**From:** Miller, Ed  
**Sent:** Wednesday, May 13, 2015 3:21 PM  
**To:** Hardgrove, Matthew; Jenkins, Joel; Jackson, Christopher; Pascarelli, Robert; Poehler, Jeffrey  
**Subject:** Duke/Westinghouse Presentation Slides for 5/19/15 Public Meeting on RAPTOR  
**Attachments:** Duke Final slides for NRC RAPTOR presentation dated 5-12-15 rev 0.pdf; Catawba Unit 1 MUR RAI Whitepaper Slides\_prop3\_NRC.PDF

## Justification for the use of RAPTOR-M3G for the Catawba Unit 1 Measurement Uncertainty Recapture Power Uprate (MUR) Fluence Evaluations

- Duke requested this meeting to present its written response to RAI SRXB-RAI 8.
- *(RAI SRXB-RAI 8) The RAPTOR-M3G code used to calculate fluence for MUR conditions does not appear to be approved by the NRC for use in this scenario. The NRC staff requests that the licensee provide justification for the use of RAPTOR-M3G for fluence calculations for MUR conditions, or provide an alternative fluence calculation using an NRC approved method.*
- This meeting coupled with additional technical information submitted to the NRC provides the justification for the use of RAPTOR-M3G for the Catawba Unit 1 MUR Power Uprate Fluence evaluations.

# Catawba U

- URE model – 209 radial, 195 azimuthal, and 89 axial mesh intervals

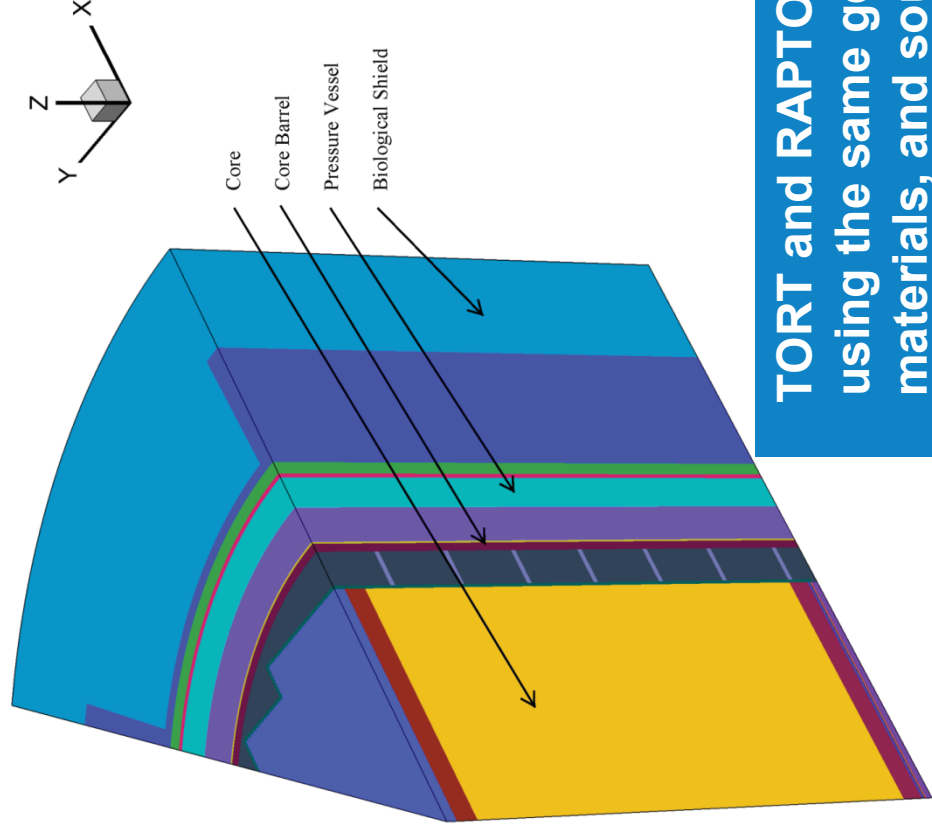
- Westinghouse/Duke are providing justification to the NRC that the use of RAPTOR-M3G for fluence calculations for MUR conditions is acceptable.
- Additional Catawba Unit 1 specific benchmark calculations have been done between TORT and RAPTOR-M3G
  - For limiting RPV materials
  - For representative fuel cycles
- Due to computer limitations with TORT, three reduced size models were used:
  - Upper Reactor Environment (URE) model (Weld 06)
  - Midplane Reactor Environment (MRE) model (Weld 05)
  - Lower Reactor Environment (LRE) model (Weld 04)
